MEMORANDUM

DATE: February 2, 2016

SUBJECT: BZA No. 19175 – Special Exception from rear yard requirements and Area Variance relief from side yard and loading requirements, for construction of a new residential building at 2 Eye Street, SE – Square 659W, Lot 21

Figure 2. Site Plan

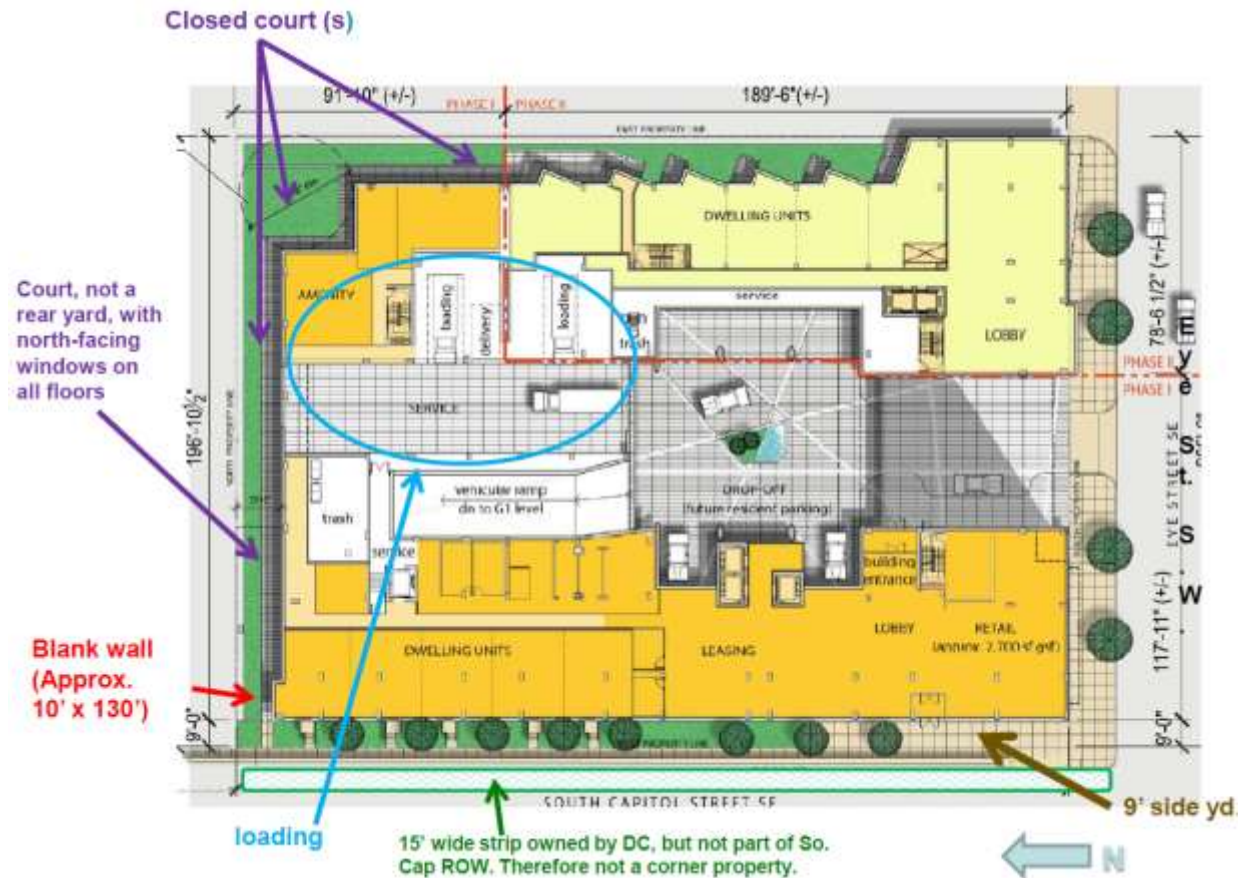
There are no buildings facing the rear of the proposed property, nor is OP aware of any development proposals for the property to the north. As shown on Figure 2, for the areas of the northern façade where windows are proposed there would be no less than a fifteen foot distance between the proposed building and the site's northern property. The distance would be approximately 12 feet from the property line for the portion of the northern wall without windows. These distances should provide for adequate light and privacy for the apartments.

Figure 3. Roof Plan as of February 1, 2016 (Exhibit 24A)

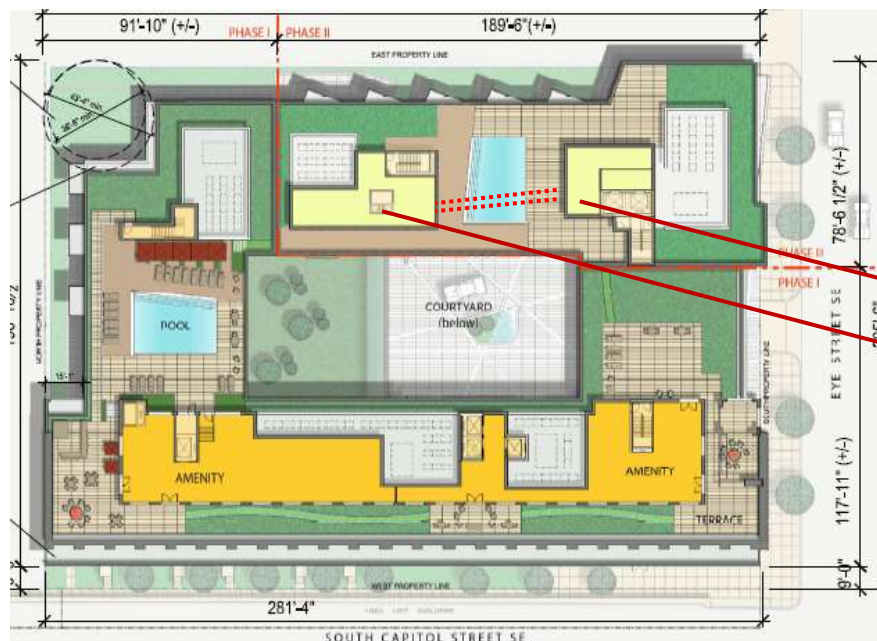
The applicant's February 2, 2016 filing (Exhibit 26) withdrew the request for a special exception from §§ 777 and 411.6 to permit a separate third penthouse that included an egress stair and communal recreation space but not a separate elevator core. The applicant has informed OP that the revised penthouse plan will include a meaningful connection between what had been separate penthouses in earlier plans.

Applicant has informed OP that revised roof plan will be filed with meaningful connection and single Phase II penthouse
